Job	Truss	Truss Type	Qty	Ply	LOT 10 PROVIDENCE CREEK 233 PROVIDENCE CREEK DRIVE FUQUAY
24-5028-R01	R04RP1	PIGGYBACK BASE	15	1	Job Reference (optional)

REPAIR(S) REQUIRED

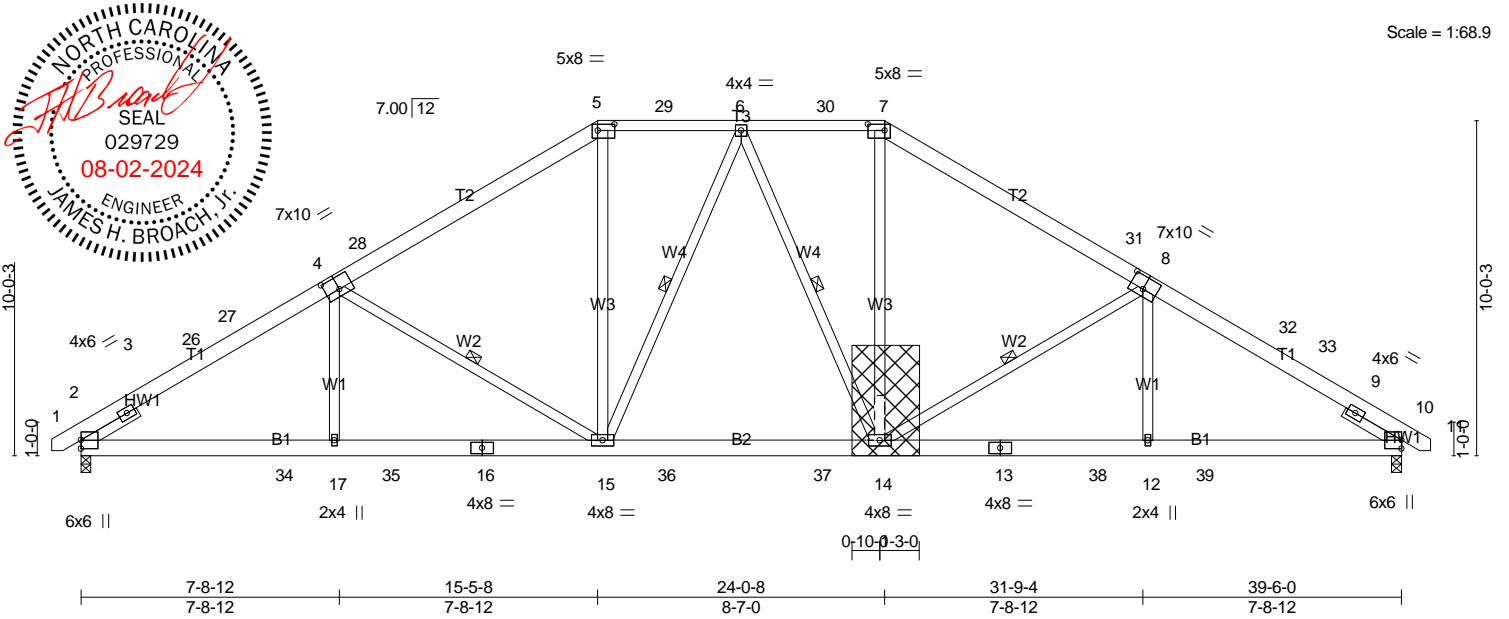
- 1) Repair Condition: Vertical web 7-14 has damaged section 1-4-0 long starting 0-0-0 above joint 14.
- 2) Attach 40"H X 25"W X 7/16" OSB (APA Rated Sheathing 24/16 Exposure 1) gusset to both sides of truss at joint 14 with 10d (0.131"x3") nails from each face, driven through both sheets of plywood and clinched. Connected together as follows: 2x6 - 2 rows 0-8-0 o.c., 2x4 - 2 rows 0-6-0 o.c. Minimum 0-3-0 end distance.
